FINAL ENVIRONMENTAL ASSESSMENT  
AND  
COASTAL ENGINEERING EVALUATION  
FOR  
SHORELINE SETBACK VARIANCE APPLICATION

Gary and Marcia Okimoto  
84-119 Maka'u Street  
Wai'anae, Hawai'i 96792  
TMK 8-4-10:13, Lot 315

Prepared by:  
Sea Engineering, Inc.  
Makai Research Pier  
Waimanalo, Hawaii 96795

**DRAFT ENVIRONMENTAL ASSESSMENT  
REVIEW COMMENT AND RESPONSE LETTERS**

FIGURE 7. SITE PLAN OF PROPOSED HOME

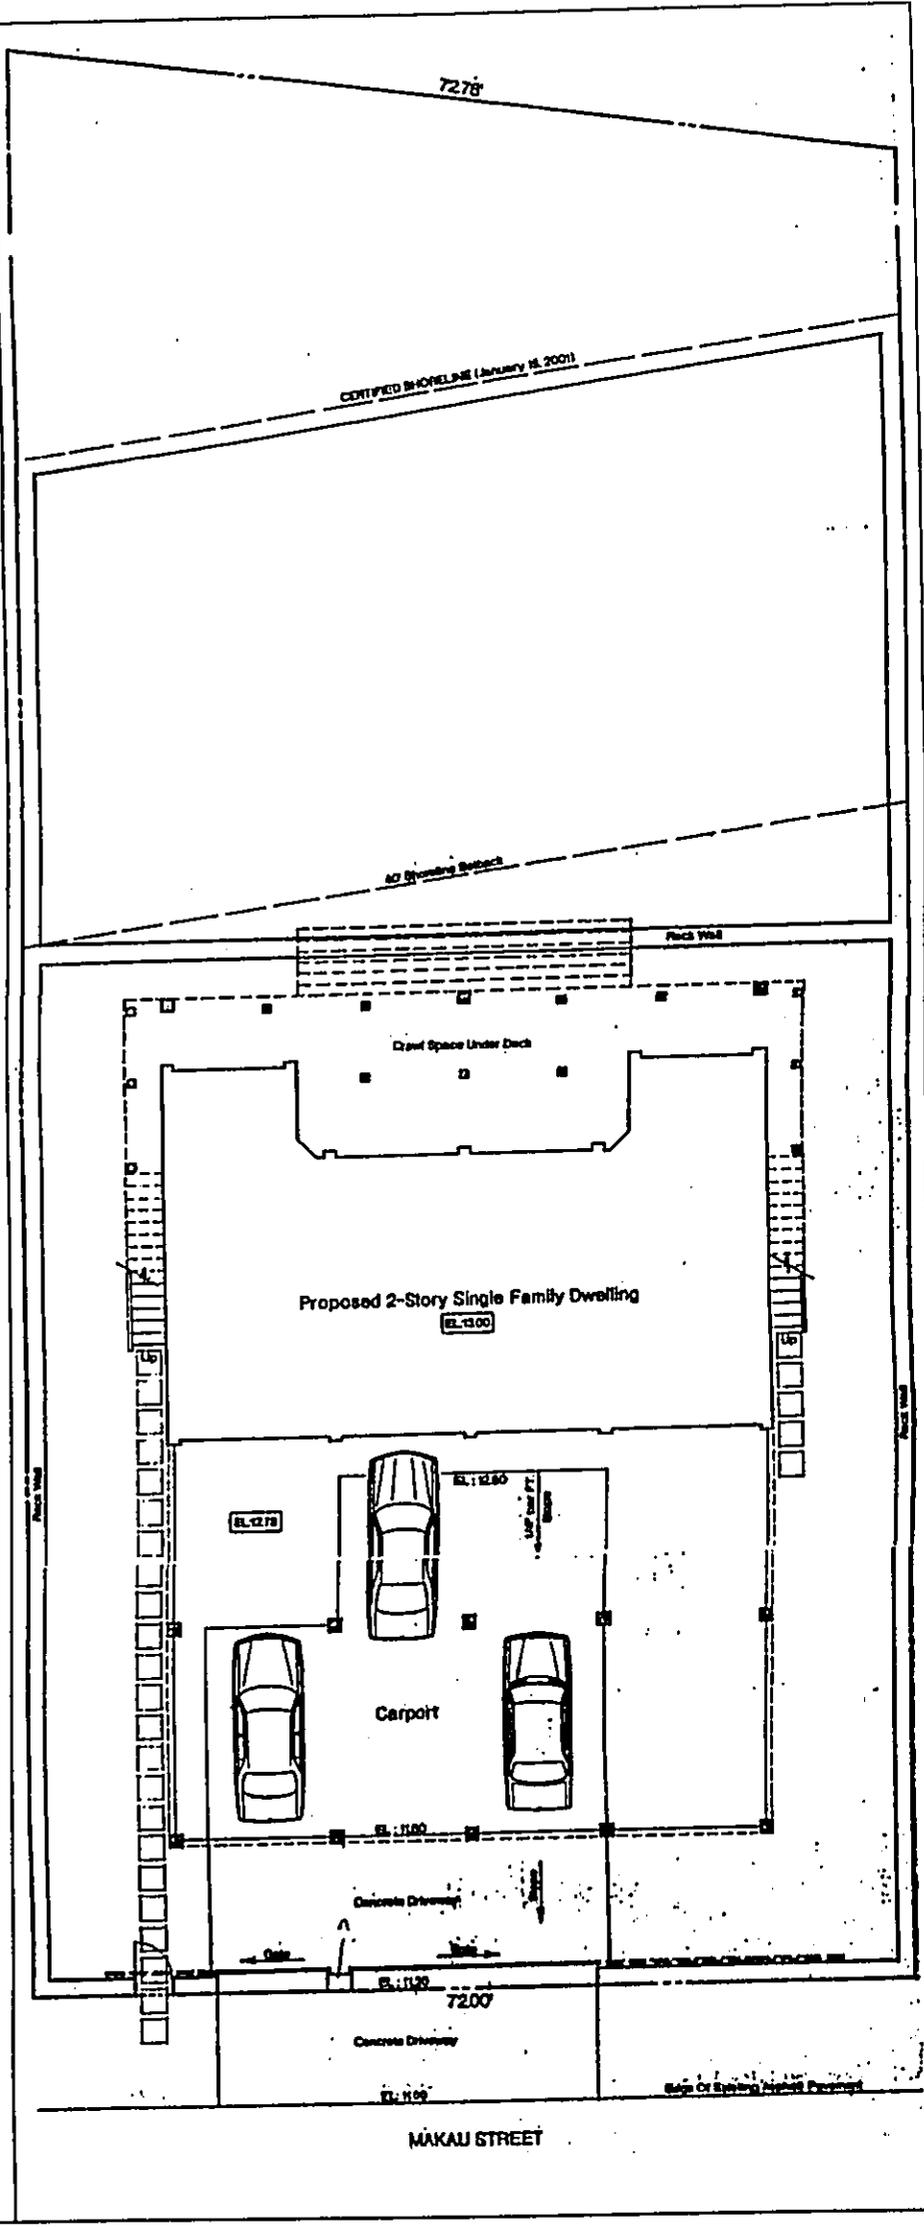
According to figure 7 in the draft EA the house will be located as little as 10.5 feet behind the 40-foot setback, with the deck as little as 5.5-feet being the setback. We are not convinced that this is far enough back to prevent damage to the structure. We suggest designing the house to allow access to a parking area on the oceanside of the structure, thus allowing a greater distance between the house and the ocean.

The proposed home to be built on the property will be located approximately 160 feet landward of the mean higher high water tide line, and well inland of wave runup resulting from typical occurring (non-storm) high wave action. The house will be situated on the landward half of the property, set back approximately 90 feet from the seaward property line. In order to move the house any further landward it would have to be reduced significantly in size, which would not meet the needs of the family. The primary purpose of the wall is to prevent wave runup during extreme storm events, such as occurred during hurricanes Iwa and Iniki, from pushing rocks and other debris into the house. The effectiveness of the proposed wall, which is similar in design to walls protecting all of the already developed house lots in the vicinity, was illustrated during hurricane Iniki. During Iniki, high storm water levels and wave runup inundated the vacant, unprotected lots, and pushed coral rubble and rocks across the lots and onto Maka'u Street. The rest of the shoreline, which has existing shore protection structures similar to the proposed CRM wall, suffered no significant damage.
